IEEE P802.11
Wireless LANs

WWiSE Proposal: High throughput extension to the 802.11 Standard

Date: 2005-01-06

Changes and additions to IEEE Std. 802.11-1999 (Reaff 2003), as amended by published amendments IEEE802.11a, IEEE802.11g, IEEE802.11h and IEEE802.11i and by IEEE draft standard 802.11e/D9.0 are provided to support a new high throughput physical layer (PHY) for operation in the 2.4 and 5 GHz bands.

Figure 11g – MAC data plane architecture

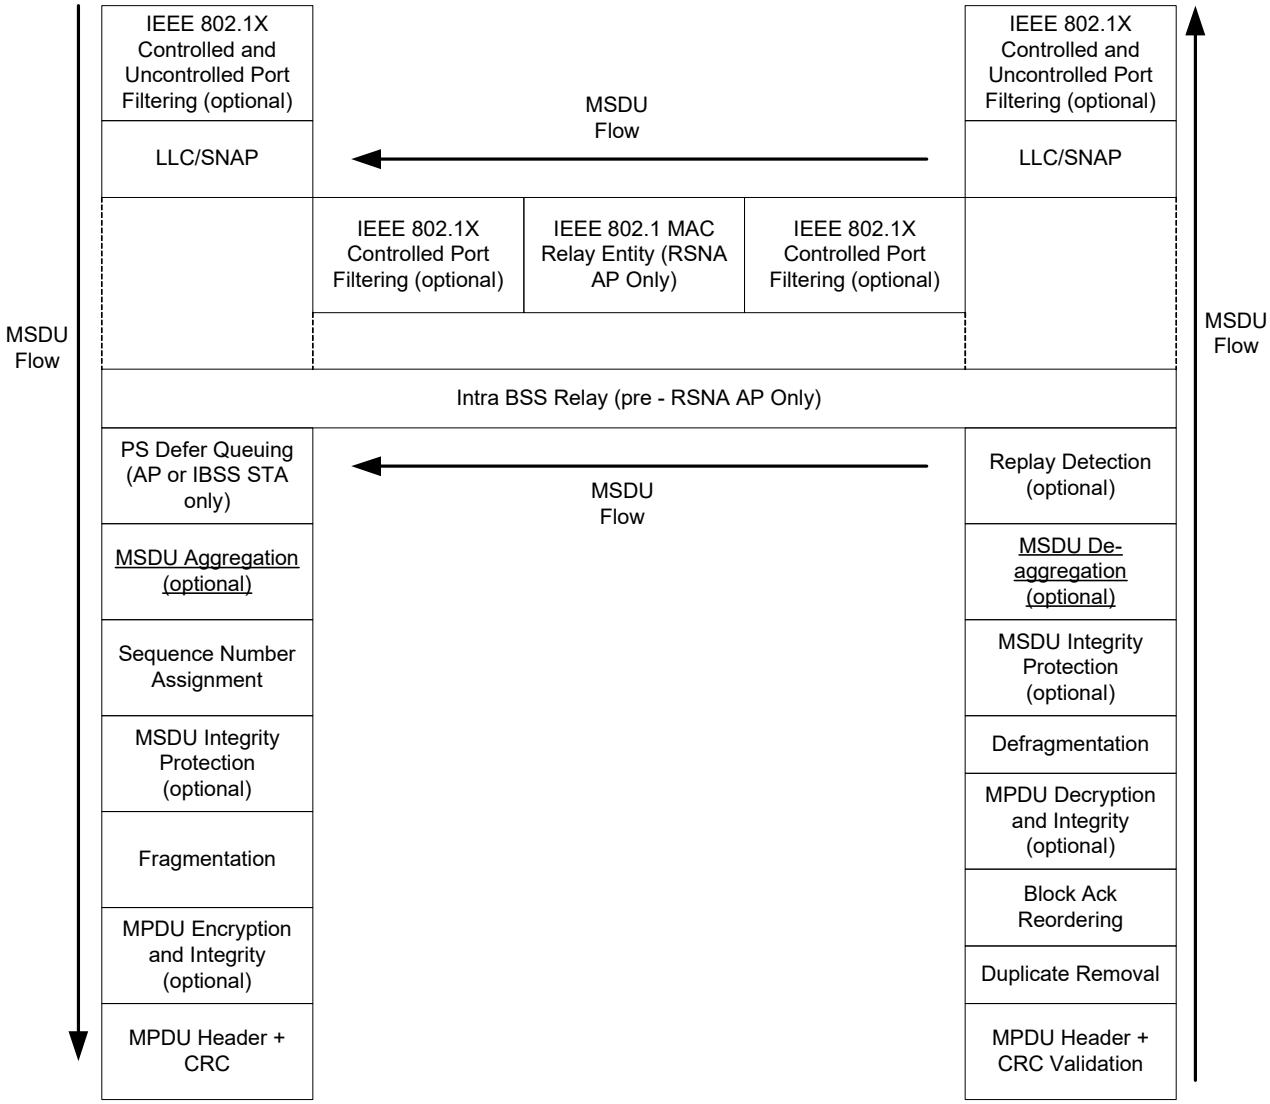
Change the paragraph in 6.1.4 (.11e) as shown:

The MAC data plane architecture (i.e., processes that involve transport of all or part of an MSDU) is shown in Figure 11g. During transmission, an MSDU goes through some or all of the following processes: frame delivery deferral during power save mode, aggregation, sequence number assignment, fragmentation, encryption, integrity protection, and frame formatting. IEEE 802.1X may block the MSDU at the Controlled Port. At some point the Data frames that contain all or part of the MSDU are queued per access category/TS. This queuing may be at any of the three points indicated in Figure 11g.

Figure 12 – MAC frame format

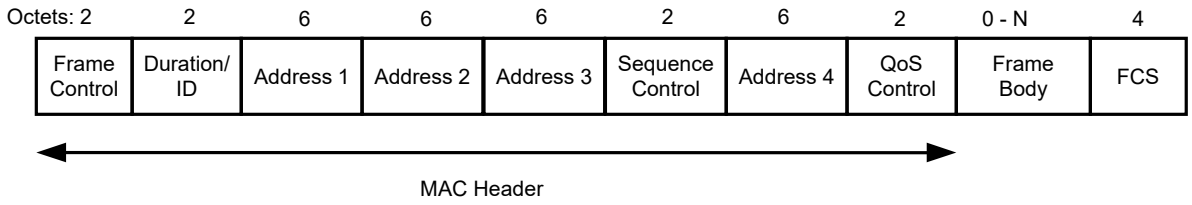
Change Figure 12(.11e) as follows:

The maximum frame body length, N, is 8100 when a Clause 20 PHY is employed, and 4000 when a Clause 17 PHY is employed.

Figure 22 – Data frame

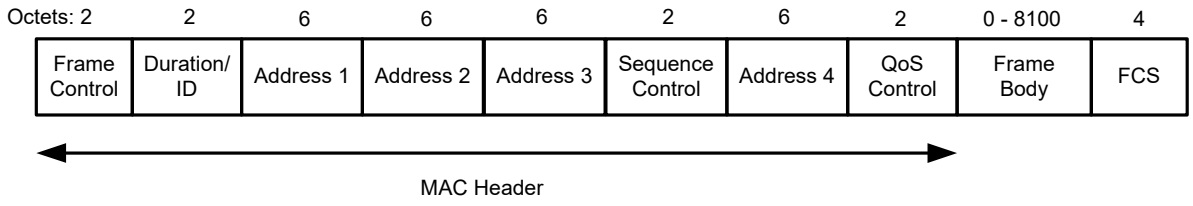
Change the text, figures and tables in 7.2.2 (.11e) as shown:

The frame format for a Data frame is dependent on the QoS subfield of the subtype field and is as defined in Figure 22.
